City Council Staff Report

Consideration of a Resolution approving the Preliminary Plat for the Maple Fields subdivision consisting of 25 lots located at approximately 1900 West 1600 South in the RA-2 zone.

Attachment "3" - DRC Comments

MAPLETON CITY DEVELOPMENT REVIEW COMMITTEE MINUTES

SHEET NO.
2

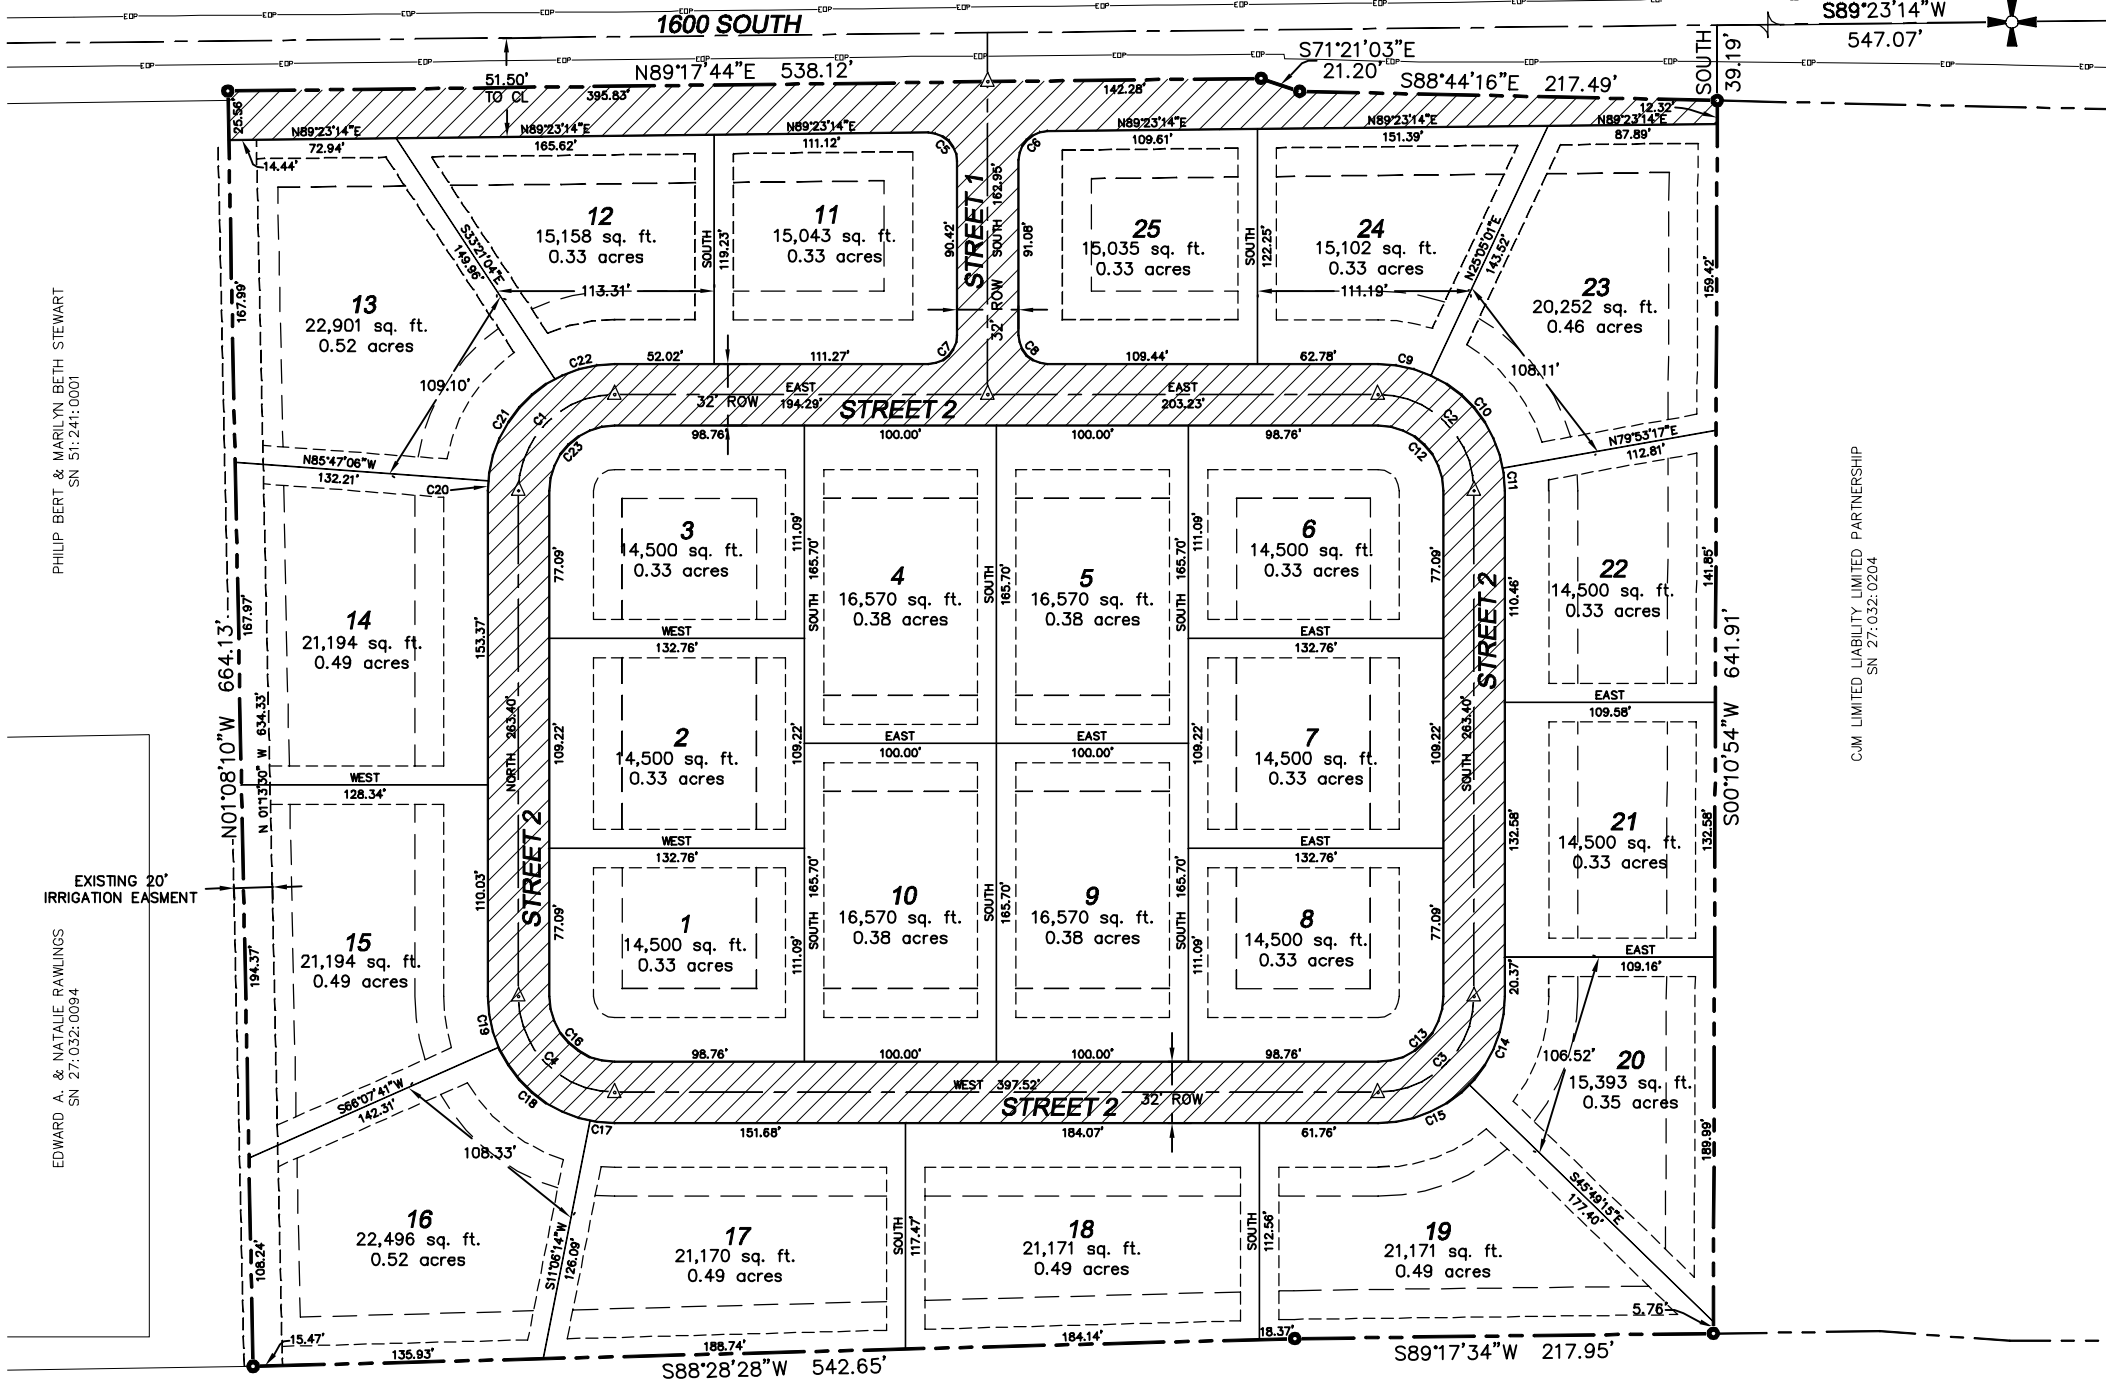
1. Submit final plat.
2. Add note to the final plat alerting future buyers that properties to the south and west have animal rights, which may result in sights, sounds and smells typical of properties with those rights.
3. A note shall be added to the plat indicating that none of the lots within this subdivision have animal rights.
4. Include the attached addresses on the final plat.

1. Provide an easement for the placement of a cluster mailbox.

1. The applicant must submit plans to RB&G Engineering (801-374-5771) to be added into the City's water model. The applicant shall be responsible for the cost of this review.
2. A site distance triangle analysis should be included in the design package showing clear zone areas in the planter strip. The wall shall be reduced to three feet in height within 30' of the intersection of 1900 W.
3. Please submit a CAD file projected in NAD83 State Plane Utah Central FIPS
4. Provide sprinkler lines and power in planter strip for irrigation.
